CANON SERVICE MANUAL

Canon FTb

CANON FTb
(REF. NO. 1-20395)

Service Manual No. C-032

Canon FTb, Black FTb, TLb Counter Connecting Lever Change

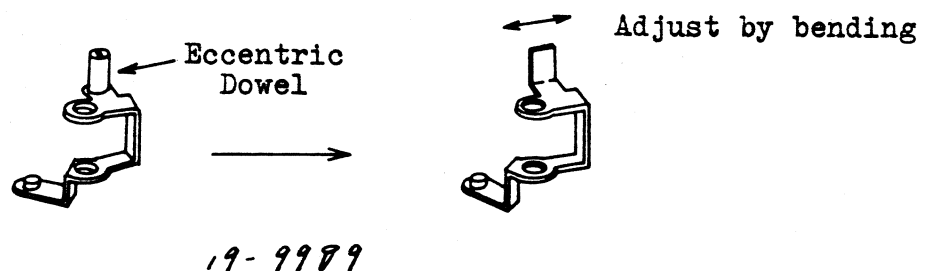
The eccentric dowel rivited onto Counter Connection Lever (19-9989) has a tendency to loosen if adjusted often. Therefore it has been replaced by a stamped ear. The adjustment is made by bending the ear.

Canon FTb Service Parts Change(Mirror Replacement)

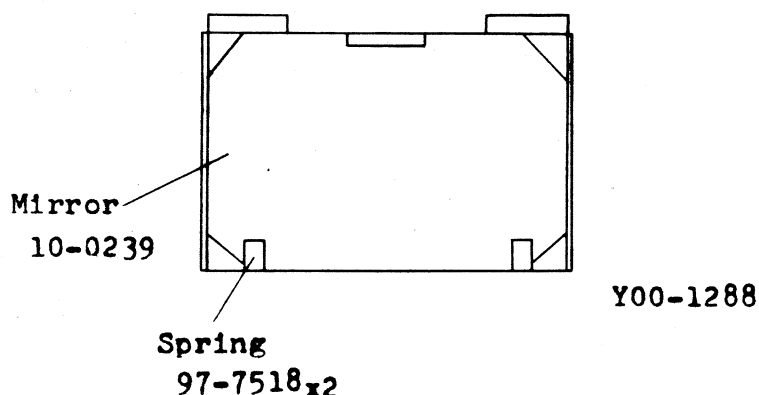
Mirror(10-0239) and Spring(97-7518) have been added to the Service Parts list so the mirror can be changed without removing the mirror box as is necessary when changing the mirror unit.

To change the mirror without removing the mirror box use the following procedure.

1. Apply a small amount of solvent (ME Ketone) to the two springs and remove them.
2. Put solvent between the mirror and the mirror base and remove the mirror.
3. Clean the mirror base with solvent.

1. Apply Plyobond to the mirror base as shown in the drawing.
2. Carefully slip the mirror under the spring at the back of the base.
3. Apply Diabond to the Springs (97-7518) x 2 and push the springs in place.

Canon FTb Brake Base Change

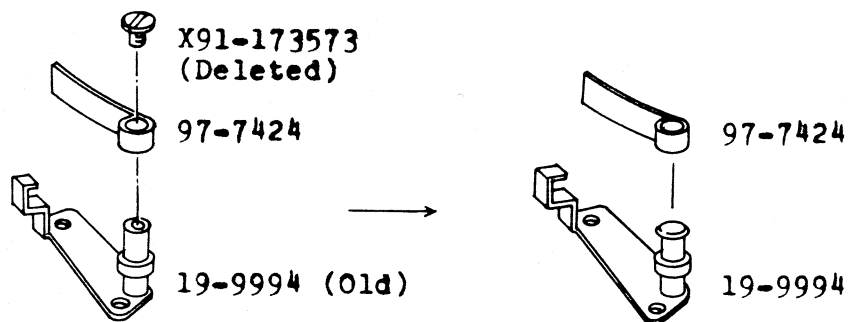
2nd Curtain Brake Base(19-9994) has been redesigned so that Screw(X91-173573) is no longer required and is deleted.Brake Band(97-7424) is now pressed onto the base.

18-0457

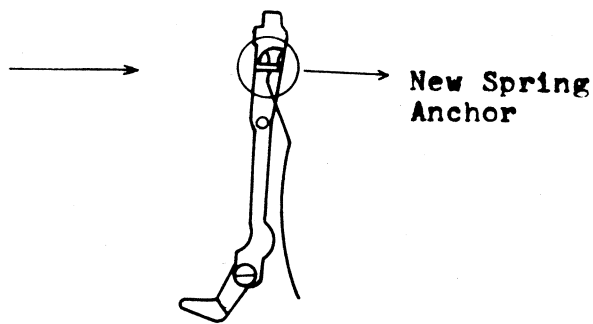
Due to results of severe vibration test, it has been found that the spring shown in the drawing can come off of the dowel. Therefore the end of the spring is now held in a hole rather than around the dowel.

Canon FTb Self Timer Change

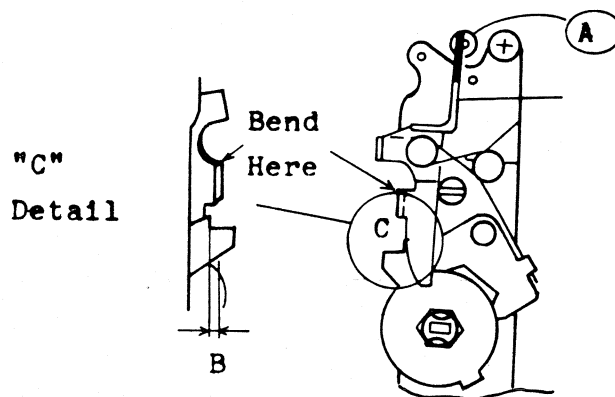
Old self timers can normally be adjusted to work by bending the tab shown toward the main body of the self timer. (This reduces the "B" dimension shown in the partial drawing.)

It is not recommended to bend the top of the lever "A" since this normally produces a temporary fix only.
